Planning Application

Project			
The Chocolate Factory Wood Green			
Drawing Title			
Proposed Plans Blocks E - D Fifth Floor			
Date	Scale	Drawn by	Check by
09.08.17	1 : 200 @ A1	RA	MK
Project No	Drawing No	Revision	
25021	PL-BE-BD-105	C

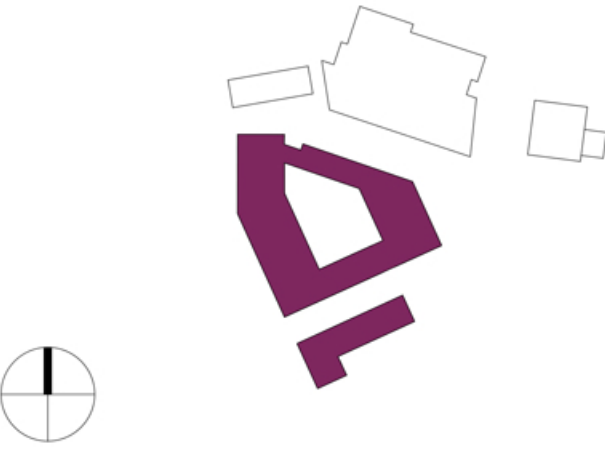
The scaling of this drawing cannot be assured				
Revision	Date	Dm	Ckd	
A	1. Block B: Removal of the tail end, free standing brick wall proposed to the south to enable future development to connect to and demonstrating that 2no storey on the south elevation can act as 'flank wall' (no residential accommodation, services access required only).	26.01.18	MK	MK

2. Block E: storey of residential units added along Western Road, Core 1 removed, commercial space increased (2 floors), duplex units along Western Road revised to open plan kitchen/ living/ dining

3. Block D: commercial proposed to the ground floor and extension of the building footprint to take in the site area, two floors of residential added to the corner, 2 storey 'flank wall' proposed to south to enable future development to connect to.

4. Block F: storey height reduced to 4050mm			
	5. Landscape: short stay cycle stand location amended, gate/ barrier to north of The Chocolate Factory added			
B	Revisions to heights of Block B, D and E	16.02.18	CG	PJ
C	Block E: Core 2 north east corner: high level non openable window provided in the kitchen	26.04.18	MK	MK
